Wheaton Woods, Preliminary Plan No. 120160060

Completed: 2/11/16

PRELIMINARY PLAN RECOMMENDATION AND CONDITIONS

Figure 5: Waiver Request for Street Frontage exhibit - Lots 23 and 24

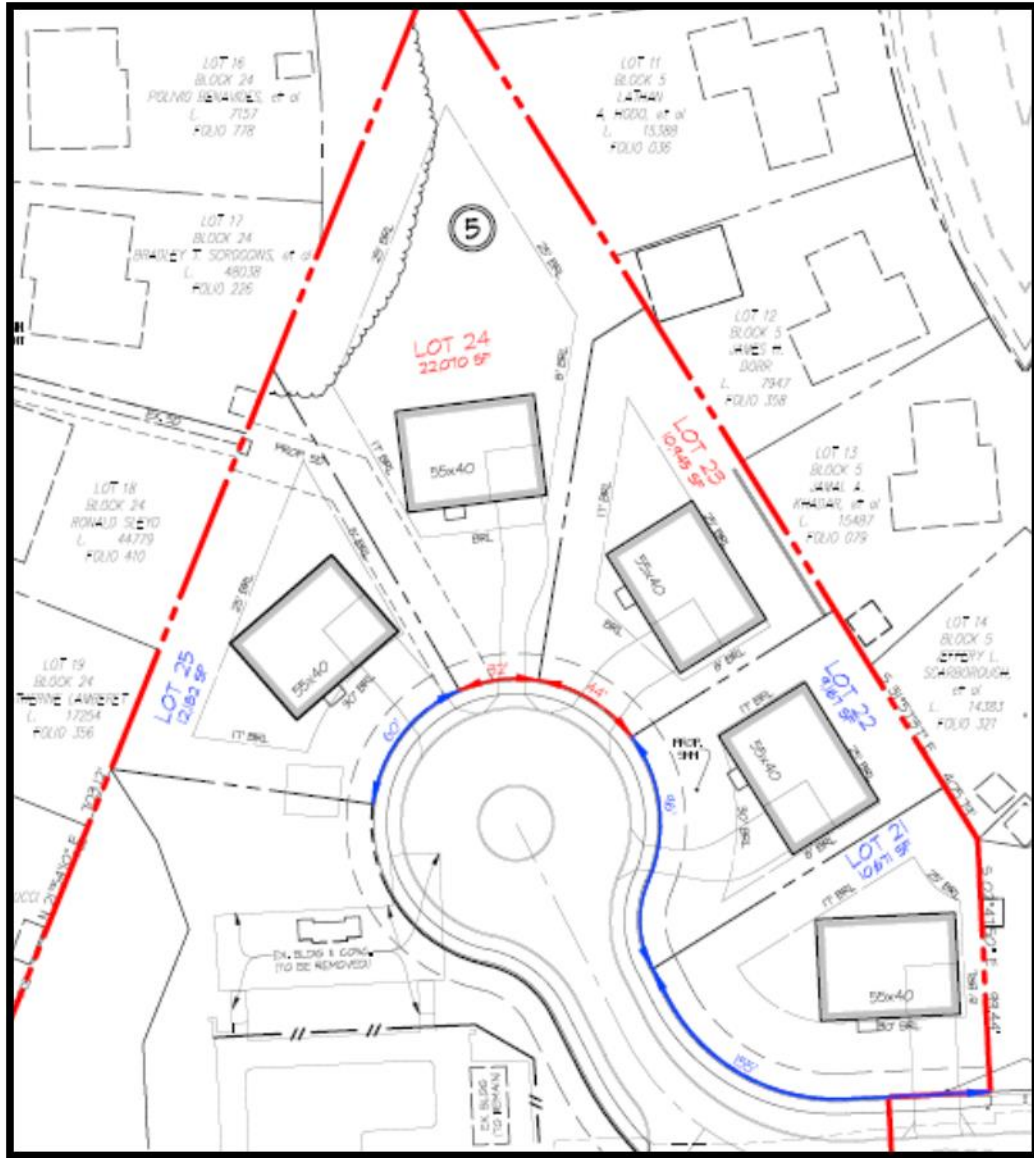
7. **Street Frontage** - The proposed resubdivision does not meet the street frontage criteria. Proposed Lots 21, 22, and 25 have street frontages of 122, 96, and 60 feet, respectively, and are within the range of the lots in the defined neighborhood (+60 feet to +262 feet). Proposed Lots 23 and 24 have street frontages of 44 and 32 feet, respectively, and do not meet the resubdivision criteria. The Applicant is therefore requesting a waiver pursuant to Section 50-38(a)(1) of the Subdivision Ordinance as discussed below (and in Attachment 5).

The proposed resubdivision cannot meet the street frontage criteria because of the shape of the Subject Property, its location within an existing neighborhood with access only from one public street which terminates at the property, and the size and configuration of the revised lot for the existing community pool. Since all new lots are required to have frontage on a public street, the extension of the existing Landgreen Street into the Subject Property with a cul-de-sac is the only feasible way to provide adequate public access and meet all other relevant fire and safety requirements. And since cul-de-sacs have wedge-shaped lots at the terminus (for Lots 23, 24 and 25 in this case), it is impossible for all new residential lots around the proposed cul-de-sac to have similar frontages as the lots in the neighborhood which does not have cul-de-sacs. Therefore, the Applicant has requested a waiver of the resubdivision analysis

In addition, Staff recommends the Board grant the requested waiver to the frontage requirement of the resubdivision criteria for Lots 23 and 24. Staff also recommends the Board accept design exception approved by MCDOT for a modified Tertiary Street Standard MC 2001.01 with a 44-foot-wide right-of-way, and that the Board reclassify the existing Landgreen Street between the Subject Property and Marianna Drive as a Tertiary Street.

Figure 6: PFCP - Variance trees exhibit

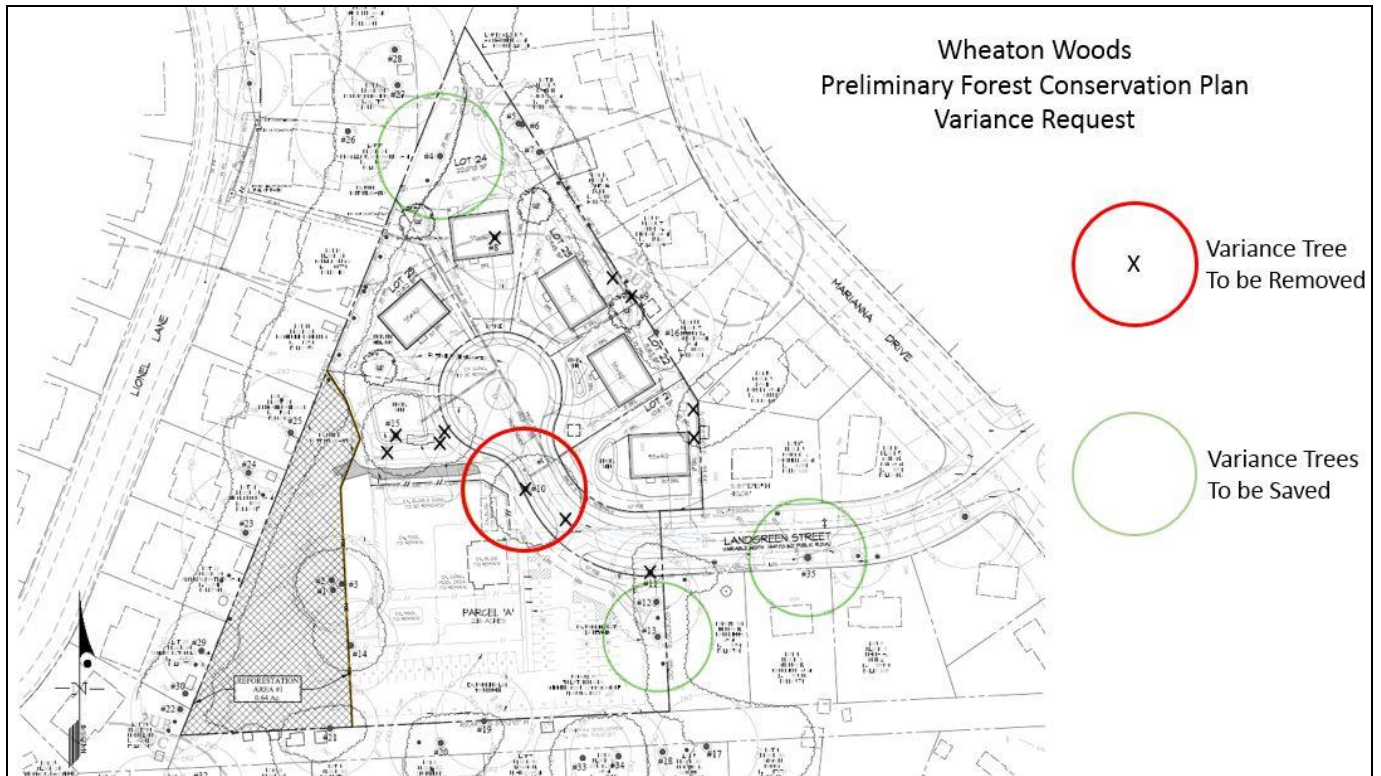
The Applicant submitted a revised variance request on December 7, 2015, because; the proposed development will create an impact to the CRZ of three trees (numbered 4, 13, and 35) that are considered high-priority for retention under Section 22A-12(b) of the County code and a fourth tree (numbered 10) will be removed (Figure 6). The other three trees will be saved. A copy of the variance request letter, specifying the amount of CRZ disturbance for the trees to be saved, is appended to this letter (Attachment 8).

In accordance with Montgomery County Code Section 22A-21(c), the Planning Department referred a copy of the variance request to the County Arborist in the Montgomery County Department of Environmental Protection (MCDEP) for a recommendation on the variance and recommended approval with mitigation (Attachment 9).
